**FIRE SUPPRESSION ASSESSMENT REPORT**

**FUEL TRANSFER INFRASTRUCTURE  
ASSESSMENT  
Red Hill Bulk Fuel Storage Facility, Hawaii  
(RHL)**

## FINAL SUBMITTAL

Delivery Order No. N3943022F4333  
A/E Contract No. N39430-20-D-2242

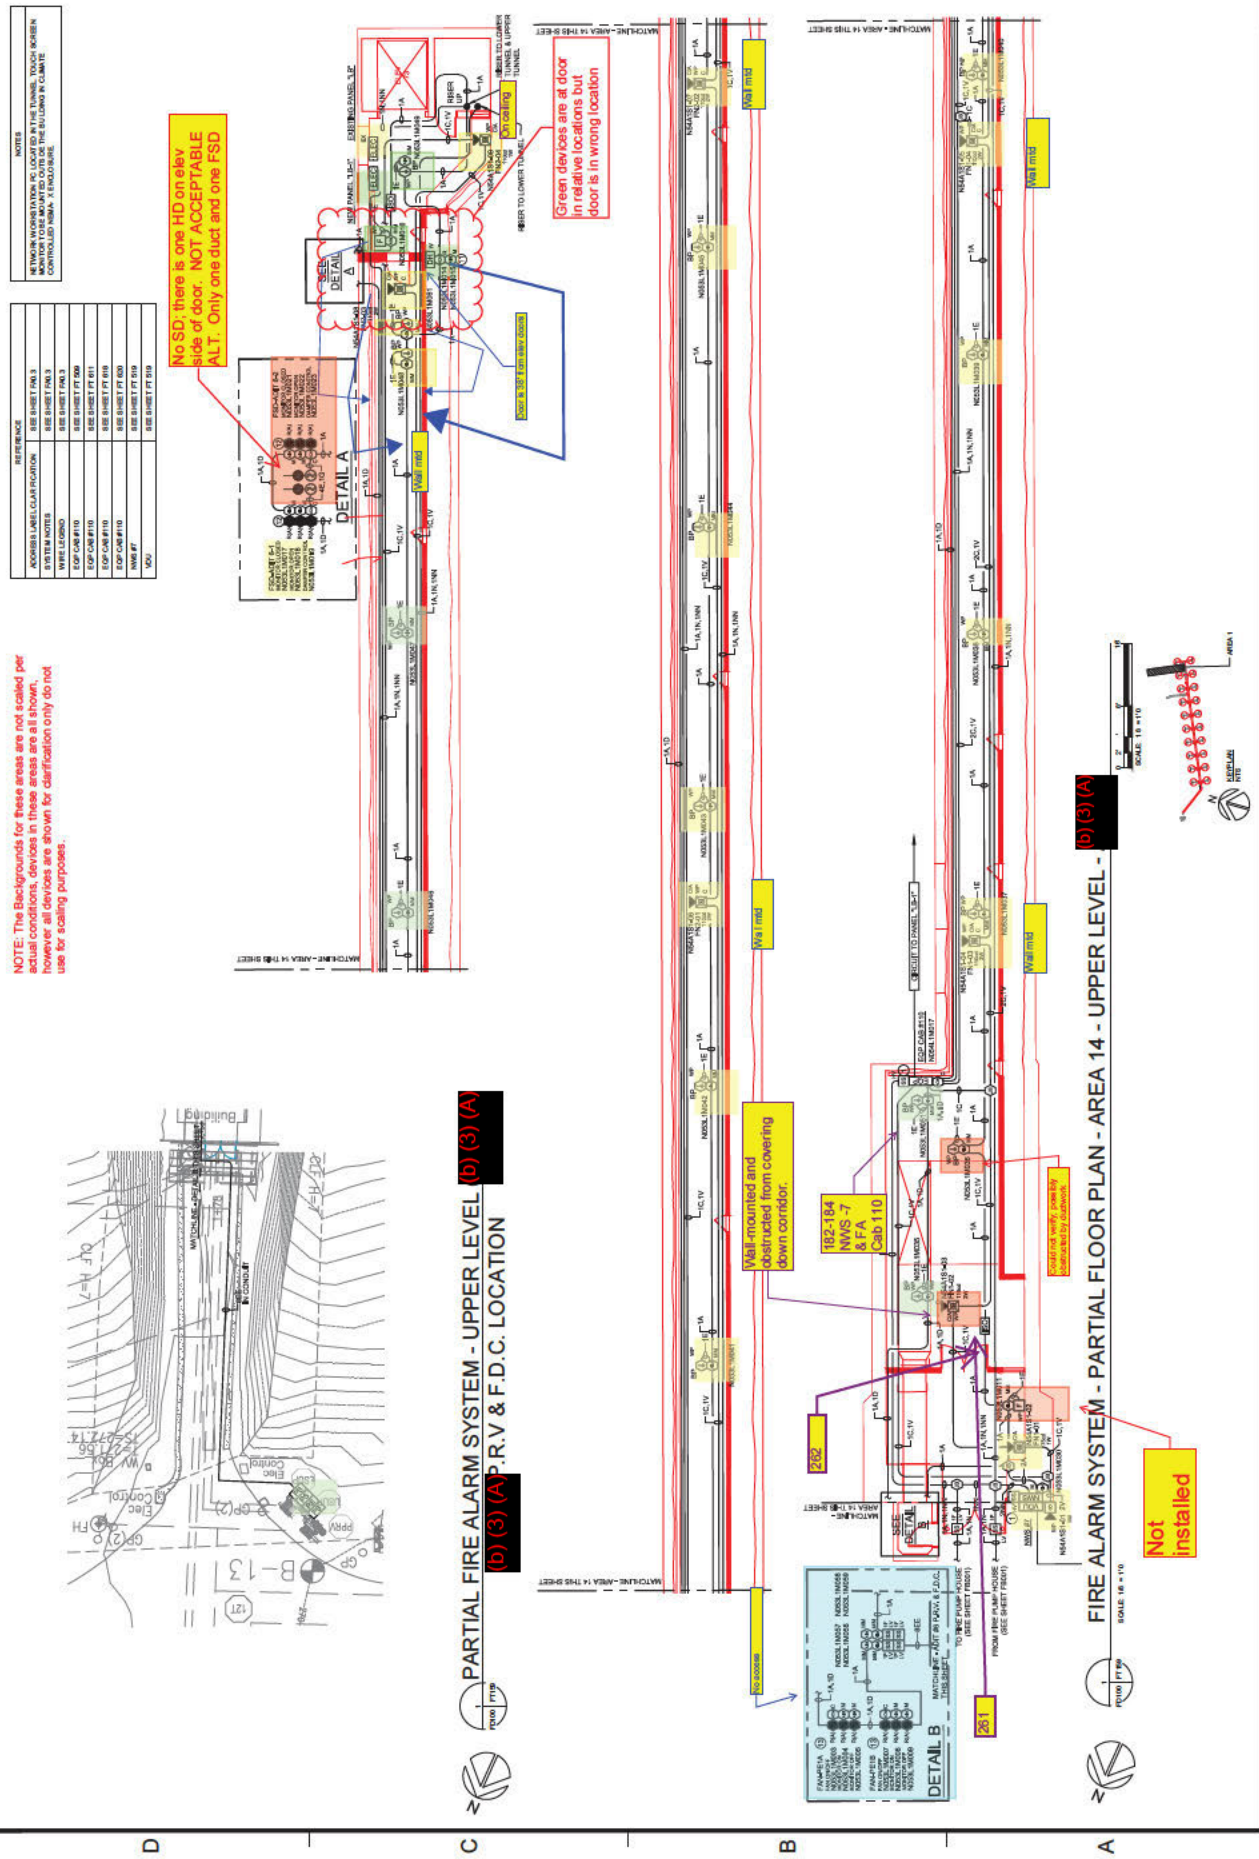
246 Completely  
 inaccessible for  
 maintenance
